Access Compliance Report

Public Rights-of-Way

Intersection ID: 8508	Main Street: W_SUGAR_CREEK_RD	Cross Street: GLORY_ST	Location: NE
ADA ID: 0EAE6BAEB40E	Ramp Type: PerpDiag	Initial Pass/Fail: Fail	Overall Compliance: No
		Severity Score: 8.75

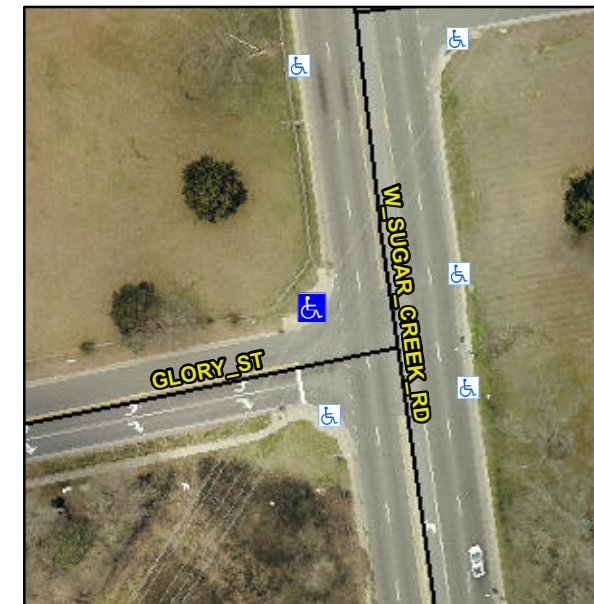
Not Found, R304.5.1

Compliance	Description	Data	Compliance	Description	Data
N/A	Ramp Length (in)	72.5	Yes	Ramp Slope (%)	8.0
No	Ramp Width (in)	47.5	Yes	Ramp XSlope (%)	0.9
N/A	Flare Type LT	N/A	N/A	Flare Type RT	N/A
N/A	Flare Slope LT (%)	N/A	N/A	Flare Slope RT (%)	N/A
N/A	Flare Traversable LT?	N/A	N/A	Flare Traversable RT?	N/A
N/A	Landing Length (in)	N/A	N/A	DWS Provided?	N/A
N/A	Landing Width (in)	N/A	N/A	DWS Contrast?	N/A
N/A	Landing Slope (%)	N/A	N/A	DWS Length (in)	N/A
N/A	Landing X Slope (%)	N/A	N/A	DWS Full Width?	N/A
N/A	Landing Curb? (Y/N)	N/A	N/A	DWS Offset (in)	N/A
N/A	Shared Landing?	N/A			
N/A	Gutter Ponding?	N/A	N/A	Gutter Slope (%)	N/A
N/A	Gutter Lip Ht (in)	N/A	N/A	Gutter X Slope (%)	N/A
N/A	Painted X Walk1?	No	N/A	Painted X Walk2?	No
	X Walk 1 Direction	To S		X Walk 2 Direction	To E
N/A	X Walk 1 Width (in)	N/A	N/A	X Walk 2 Width (in)	N/A
	X Walk 1 Slope (%)	1.5		X Walk 2 Slope (%)	4.8
	X Walk 1 X Slope (%)	2.1		X Walk 2 X Slope (%)	1.3

Remove & Replace Curb Ramp With Two New Directional Ramps or Equivalent.
